Midway City Council
2 June 2020
Regular Meeting

Resolution 2020-14 /
Zenger Annexation Agreement
Amendment and
Midway Vistas Master Plan

CITY COUNCIL MEETING STAFF REPORT

Subject: Midway Vistas Subdivision – Master Plan Review

KIRK MALMIRNF
MIDWAY VISTAS
MASTER SITE PLAN

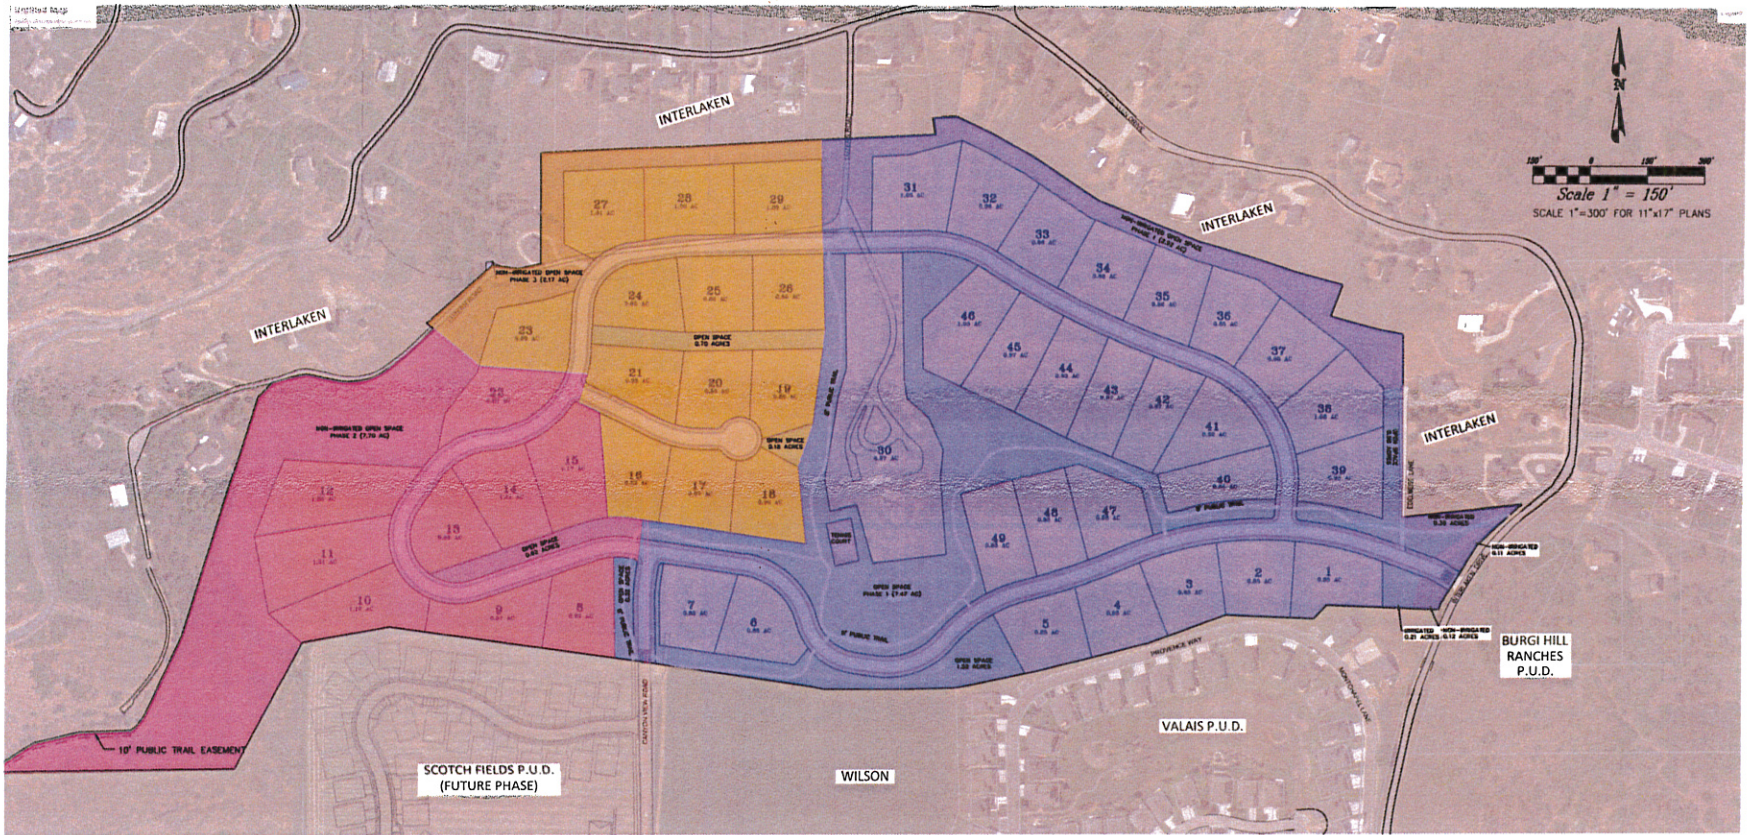
- The proposed private roads within development will have right-of-way widths of 56' with sidewalk on both sides of the road.
- As part of the annexation agreement all roads within the subdivision will be private with a public use easement.
- Any access issues relative to the town of Interlaken need to be resolved.

- An 8' public trail system is shown throughout the development. This should be shown as a private trail with public use easement.
- The trails will connect with Scott Fields development on Canyon View Road.

KIRK MAJORS
 MIDWAY VISTAS
 WATER MASTER PLAN

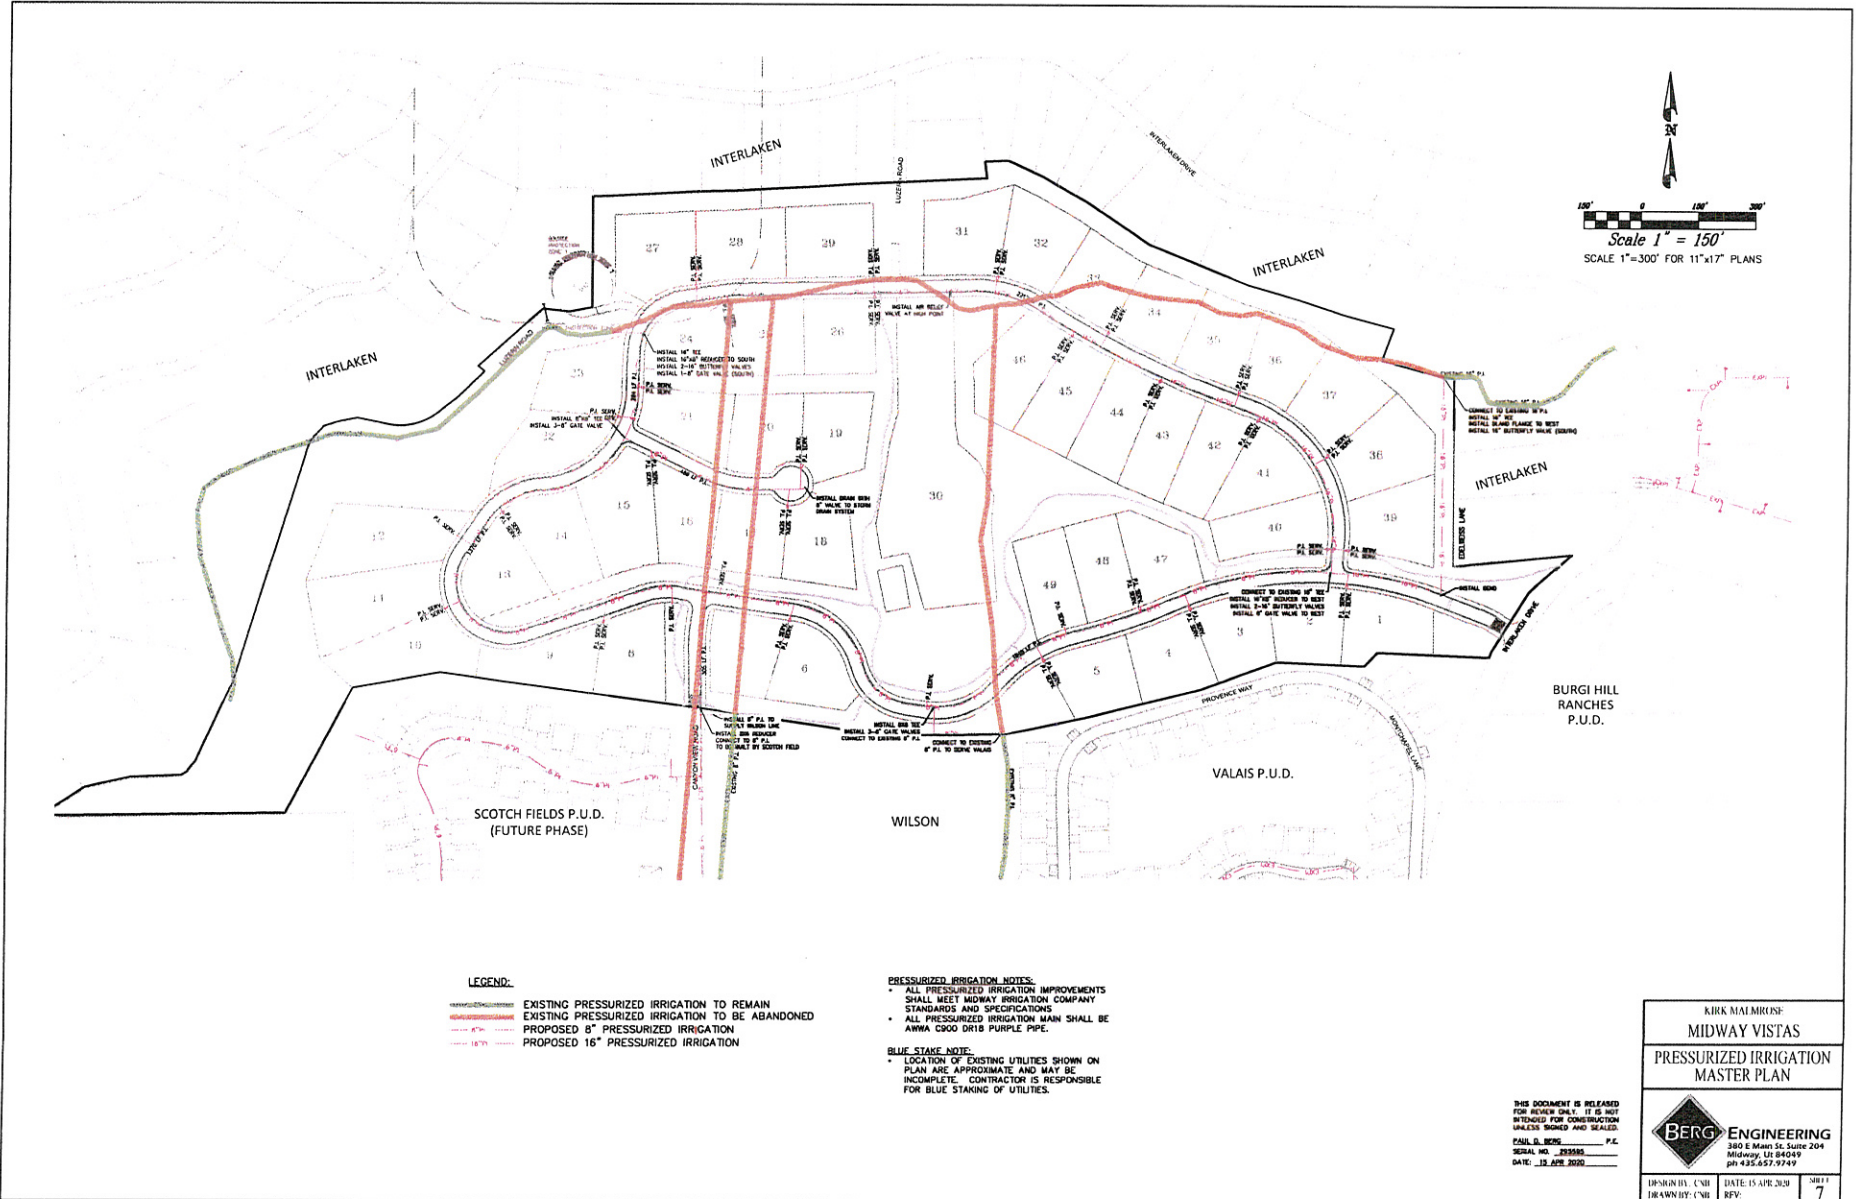
- The proposed development will be served from the Cottages on the Green pressure zone.
- The proposed development will connect to the existing 8" culinary water line in Interlaken Drive to the east of the subdivision and to a 10" culinary water line in Dutch Fields subdivision to the South of the proposed subdivision.
- To accommodate fire flows it appears a 10" water line will need to be installed throughout the subdivision. This will be addressed during the preliminary approval process.
- During the approval process we need to address the required water pressure of the highest lots.

KIRK MAURINE
 MIDWAY VISTAS
 STORM DRAIN MASTER PLAN

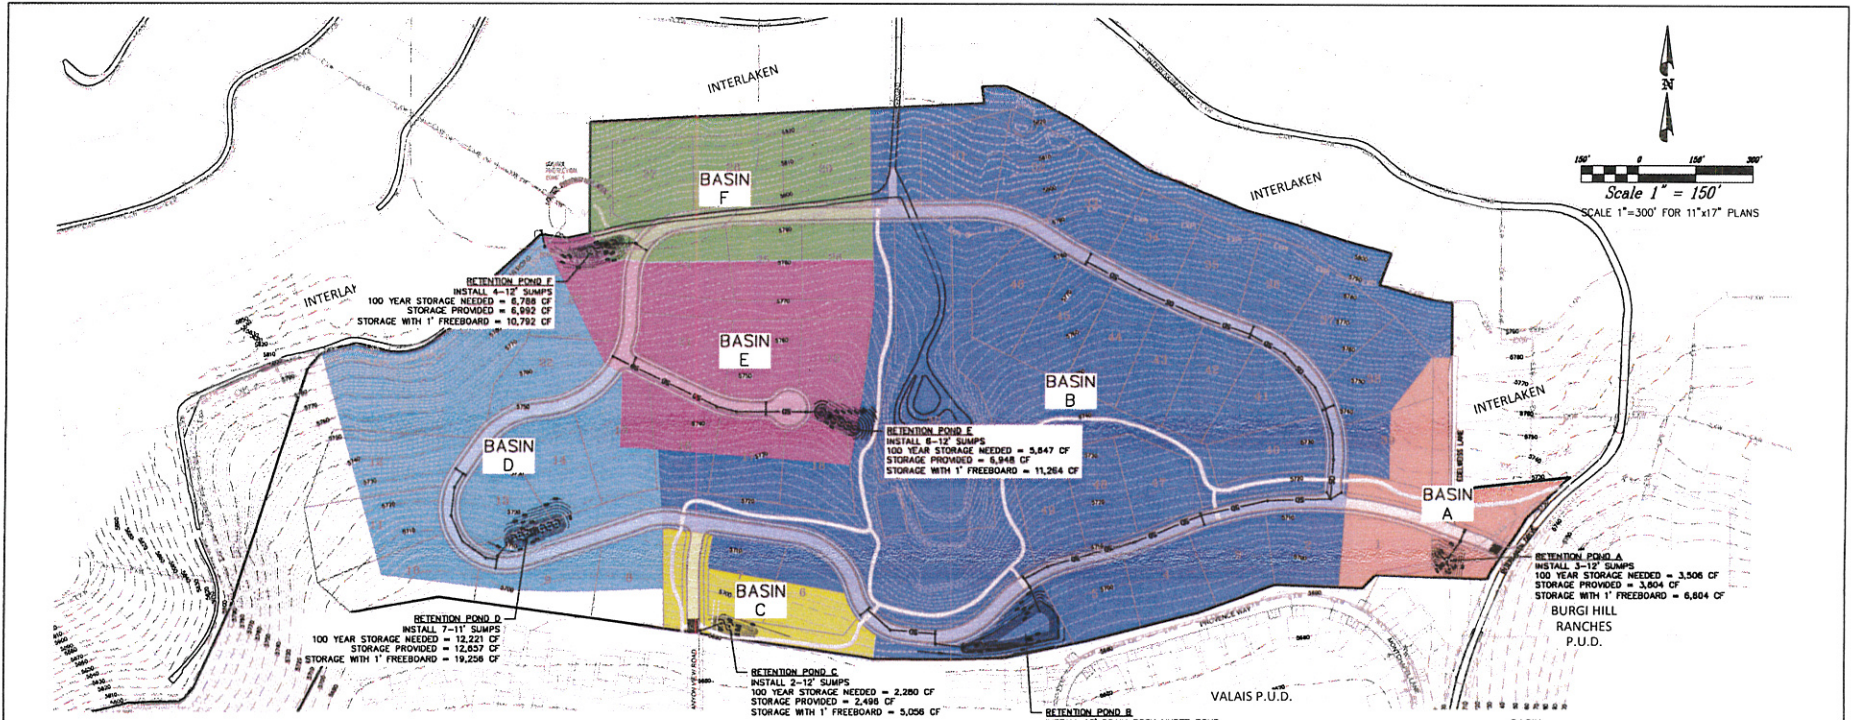
- The storm drain system will be private and will be collected within the proposed curb and gutter and discharged to a series of catch basins, sumps, and detention basins with the development.
- Midway Vistas HOA will be responsible for maintenance of the detention basins.
